CITY OF DALLAS
LANDMARK COMMISSION
Monday, November 6, 2017
AGENDA

BRIEFINGS: AGENDA

Request #1 – Proposed Fence Location (highlighted above in red)

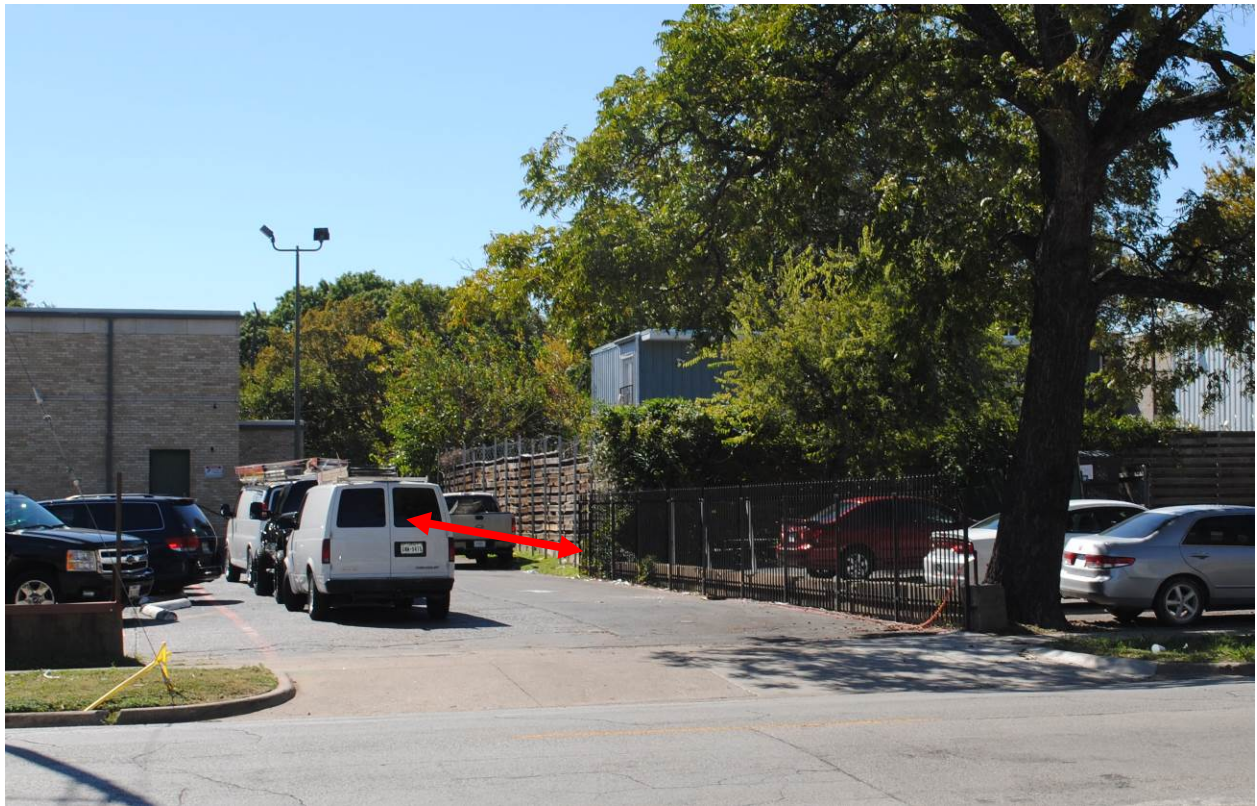
1. Install an 8ft tall board on board wood fence along northwest property line.
2. Install National Register plaque on front elevation of main structure.

1. Install an 8ft tall board on board wood fence along northwest property line. – Approve – Approve drawing and images dated 10/11/17 with the finding that although the proposed work does not comply with Section 2.7 that states that no fences are permitted in the no-build zone, except as required for school security, it meets the criteria for landmark commission approval of work that does not strictly comply with the preservation criteria under City Code

1. Install an 8ft tall board on board wood fence along northwest property line. - Approve - Approve as submitted.
2. Install National Register plaque on front elevation of main structure. - Approve with conditions - Mount screws/anchors for plaque in mortar joints.

Request #1 - Existing Brick Columns (column proposed for relocation highlighted in red)

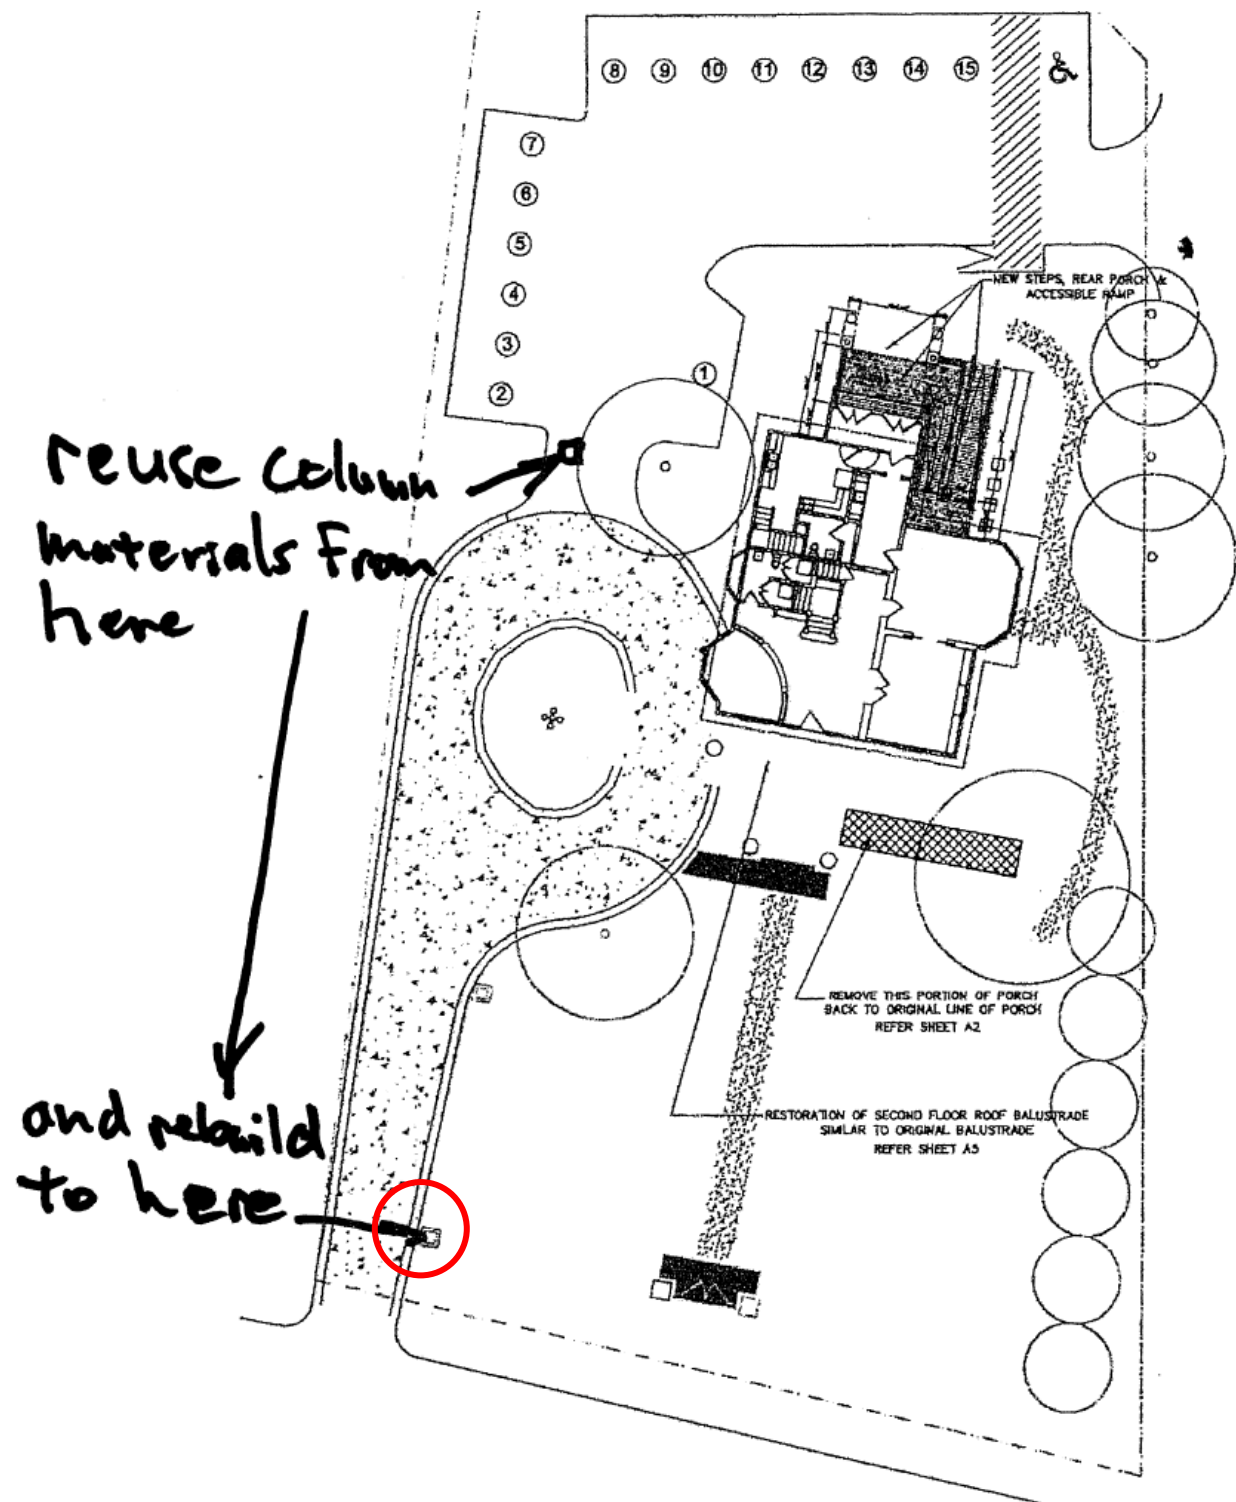
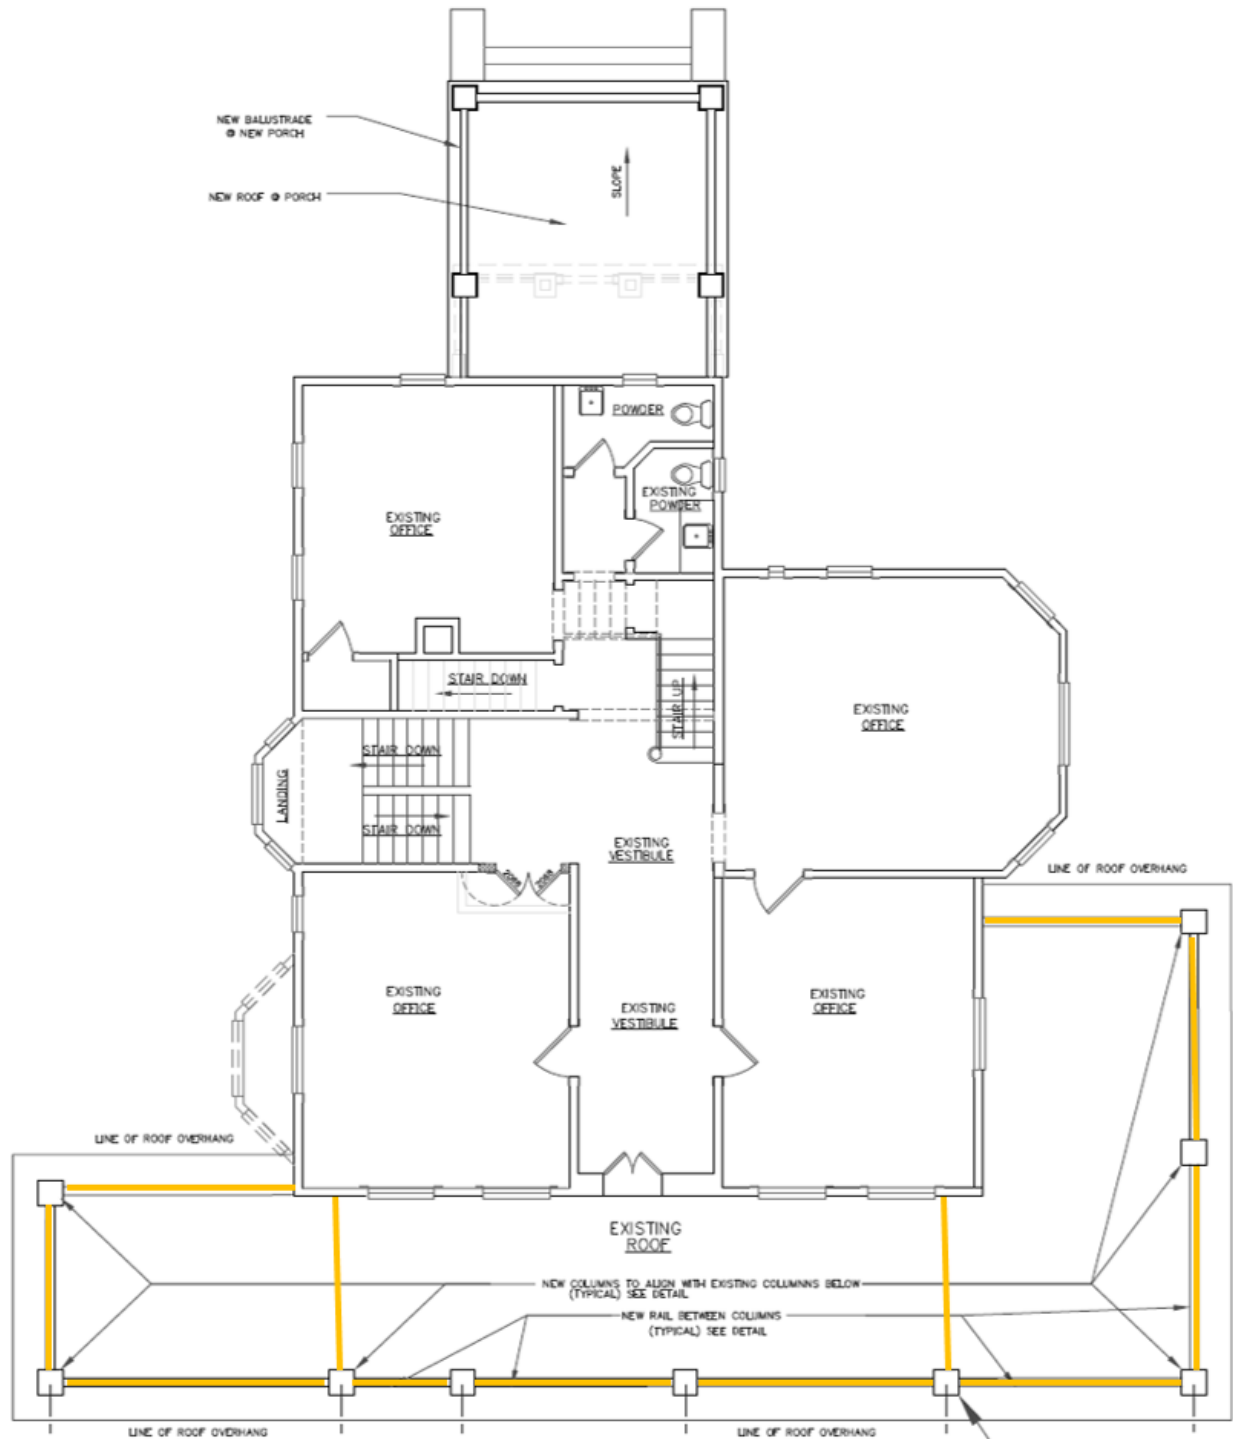
There are two brick columns located adjacent to the driveway and driveway roundabout. These columns match, in style and material, the columns that flank the pedestrian entry gate on front yard fence. However these columns are shorter than the gate columns. The north-most of these two columns appears to have been moved or reconstructed at one time. It sits atop a thick concrete base, which none of the other columns do. At the March 2017 meeting, the Landmark Commission approved modifications to the rear parking area and driveway. The north-most column requires relocation to make way for these alterations. Also approved at the March meeting was construction of a new brick column at the left corner of the front yard fence, which was necessary to help stabilize the antique metal front yard fence. The applicant is now proposing to relocate the north-most column to this location instead, and attach the metal fence to it to stabilize it.

- 1) Relocate brick column in front yard area. – Approve – Approve drawings dated 10/23/17 with the finding the proposed work meets the standards in City Code Section 51A-4.501(g)(6)(C)(i).
- 2) Replace second floor balustrades. – Approve – Approve drawings dated 10/23/17 with the finding the proposed work is consistent with preservation criteria Section 4(B) for embellishments and detailing, and meets the standards in City Code Section 51A-4.501(g)(6)(C)(i).
- 3) Install exterior lighting. – Approve – Approve drawings dated 10/23/17 with the finding the proposed work is consistent with preservation criteria Section 6 for lighting, and meets the standards in City Code Section 51A-4.501(g)(6)(C)(i).

- 1) Relocate brick column in front yard area. – Approve – Approve as submitted.
- 2) Replace second floor balustrades. – Approve – Approve as submitted.
- 3) Install exterior lighting. – Approve – Approve as submitted.

Request #2 – Proposed Second Floor Balustrade Location (highlighted above in orange)

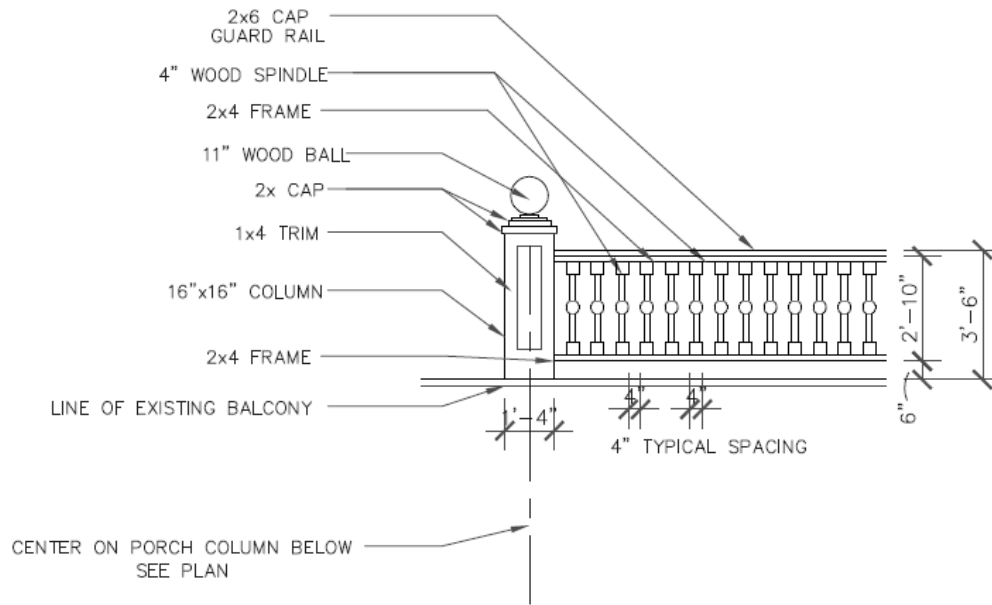
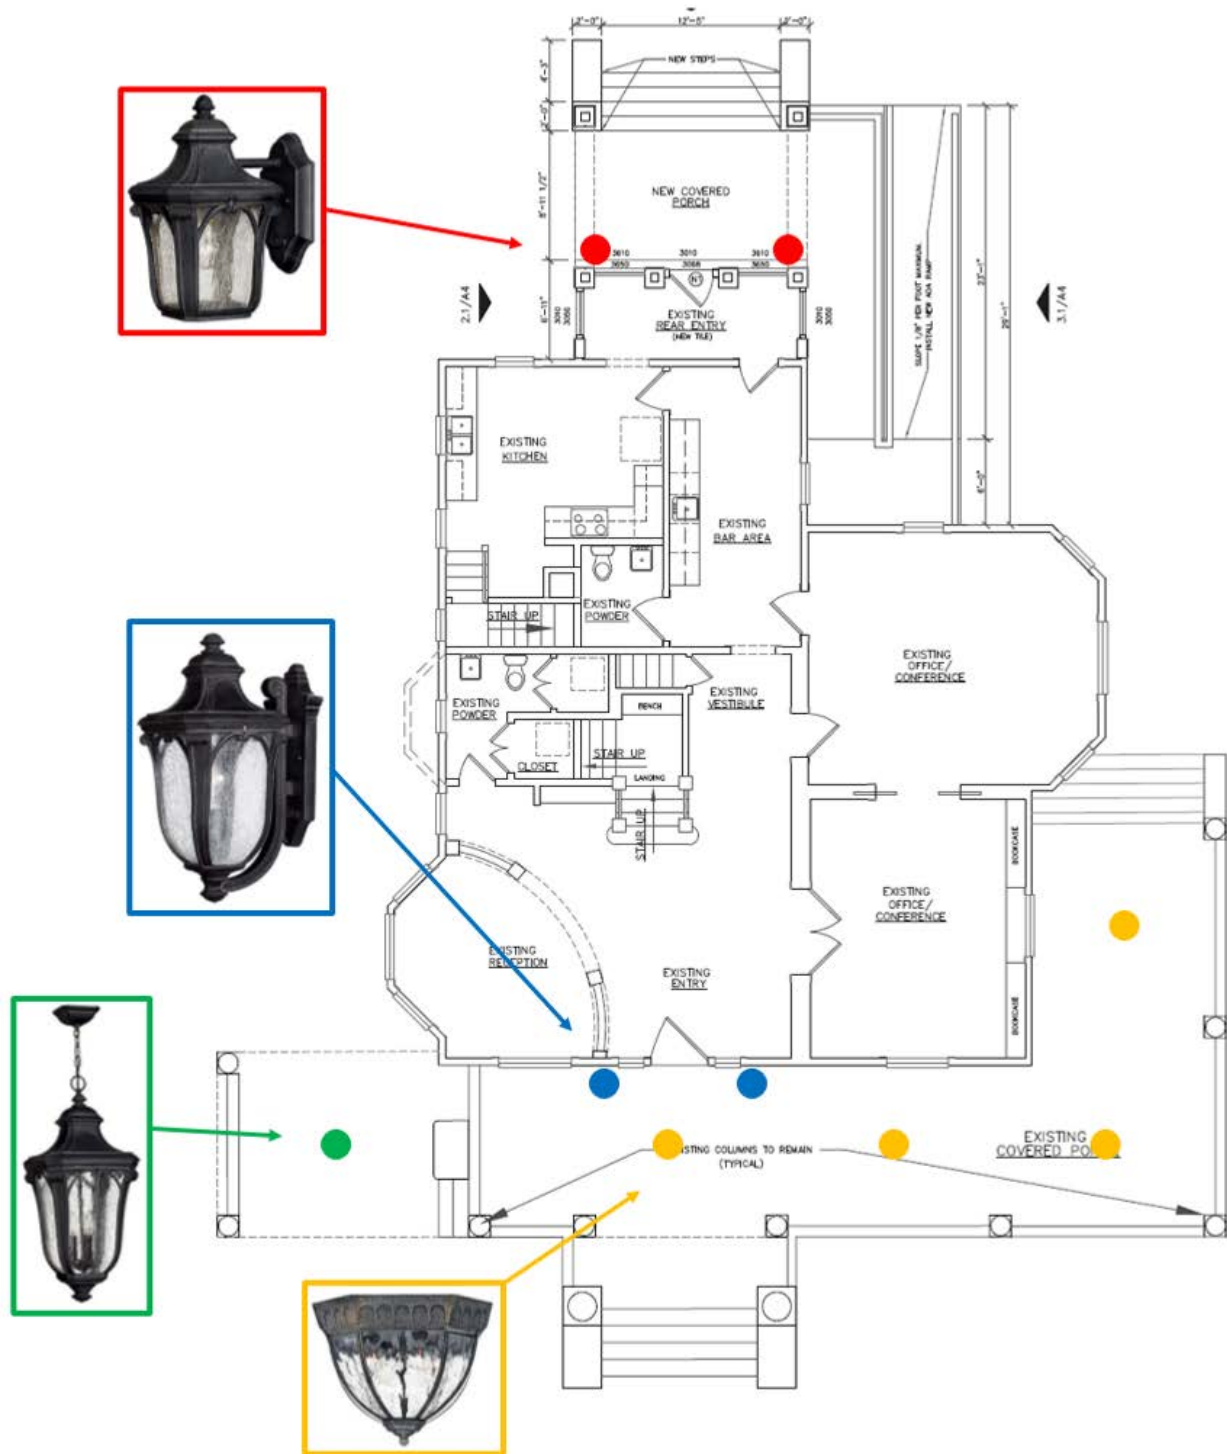
1. Relocate brick column in front yard area.
2. Replace second floor balustrades.
3. Install exterior lighting.

1. Relocate brick column in front yard area. – Approve – Approve drawings dated 10/23/17 with the finding the proposed work meets the standards in City Code Section 51A-4.501(g)(6)(C)(i).
2. Replace second floor balustrades. – Approve – Approve drawings dated 10/23/17 with the finding the proposed work is consistent with preservation criteria Section 4(B) for embellishments and detailing, and meets the standards in City Code Section 51A-4.501(g)(6)(C)(i).
3. Install exterior lighting. – Approve – Approve drawings dated 10/23/17 with the finding the proposed work is consistent with preservation criteria Section 6 for lighting, and meets the standards in City Code Section 51A-4.501(g)(6)(C)(i).

1. Relocate brick column in front yard area. – Approve -Approve as submitted.
2. Replace second floor balustrades. – Approve - Approve as submitted.
3. Install exterior lighting. – Approve- Approve as submitted.

Existing Front Elevation – Center Bay
(Note the historic concrete bumpers highlighteed above in orange.)

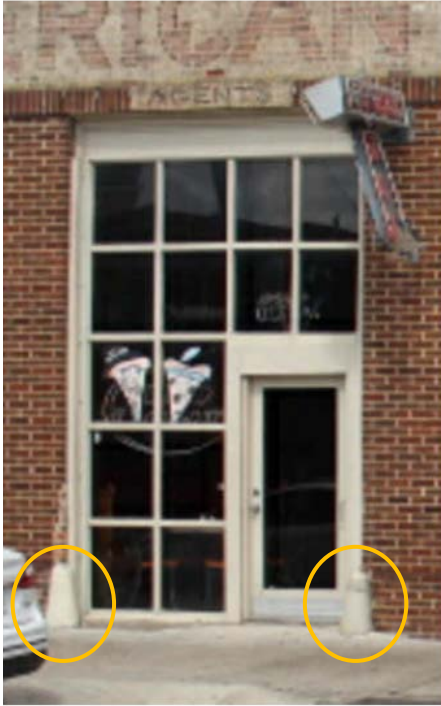
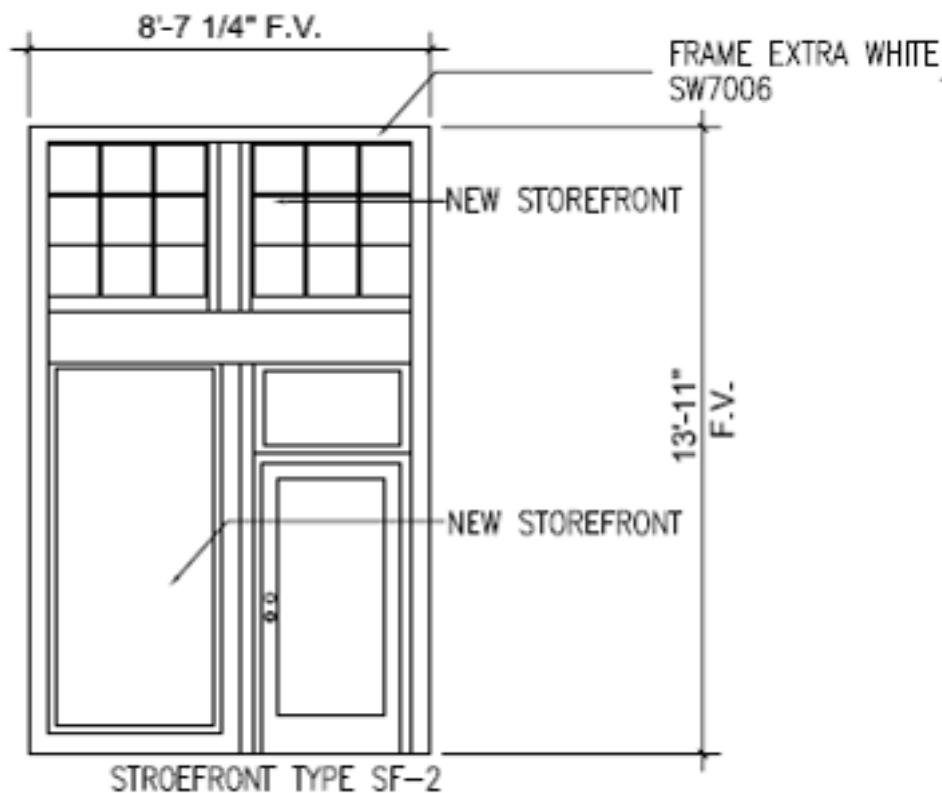
The structure is the Park Brothers Storage Building. The storefront opening in the central bay on the front elevation was originally a freight door, wide enough to permit vehicles to drive through. In 1990, this freight door opening was altered and the existing storefront window and door configuration was installed. The applicant is requesting remove the existing storefront windows and door and to install wood transoms windows with multiple divided lights to match the historic transoms in the left and right storefront bays. A wood pedestrian door with smaller transom above will be installed, also matching the left and right bays storefronts, as well as a large storefront window.

this element be removed so that the entire freight door opening is maintained. The applicant agreed and submitted revised drawings with the knee-wall removed.

- 1) Install new storefront window, door and transom in central bay on south elevation. – Approve with condition – Provide details of storefronts, specify glass to match previously approved windows above, omit brick knee-wall in center bay.
- 2) Install new storefront windows in the left and right bays on south elevation. – Approve with condition – Provide details of storefronts, specify glass to match previously approved windows above.

Recommendation / comments/ basis: Provide details of storefronts,
specify glass to match previously-approved windows
above, omit brick knee-wall in center
bay.

Proposed floor plan and partial porch elevation

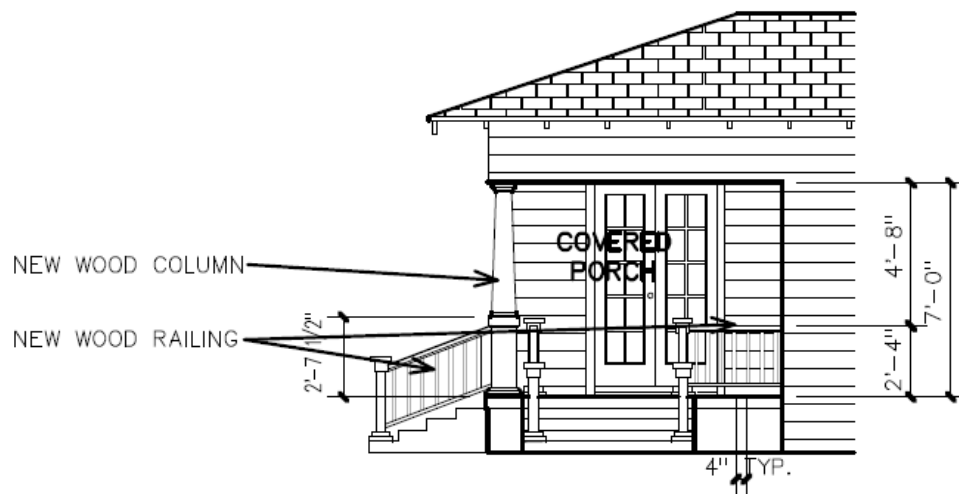
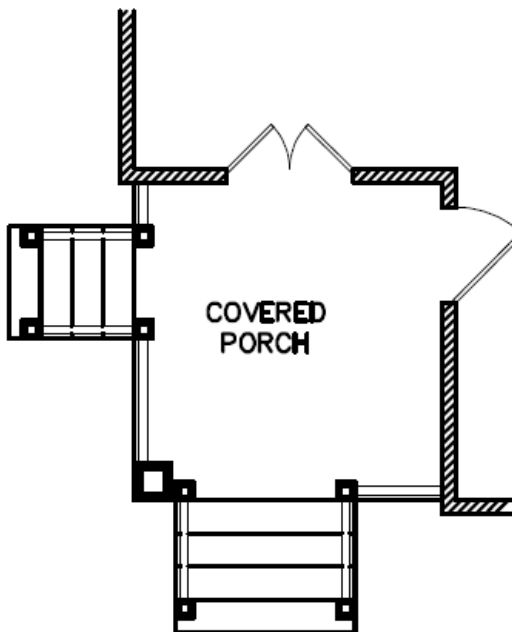
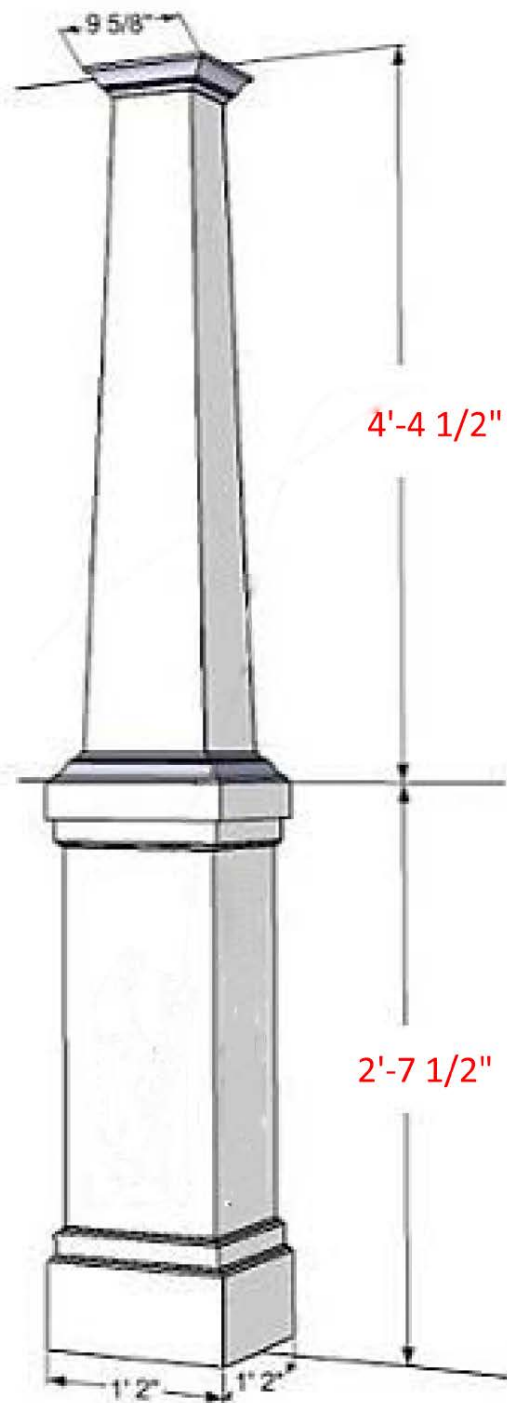
1. Install wood column and railing on front porch.
2. Replace front door.

1. Install wood column and railing on front porch – Approve – Approve drawings dated 10-16-17 with the finding that the work is consistent with preservation criteria Section 4.1(b) and meets the standards in City Code Section 51A-4.501(g)(6)(C)(i).
2. Replace front door – Approve – Approve specifications dated 10-16-17 with the finding that the work is consistent with preservation criteria Section 5.2 and meets the standards in City Code Section 51A-4.501(g)(6)(C)(i).

1. Install wood column and railing on front porch. - Approve with conditions - Recommend lowering base of column from 3'-0" to 2'-7" as well as wood railing to 2'-4".
2. Replace front door. - Approve - Provide photo of existing door.
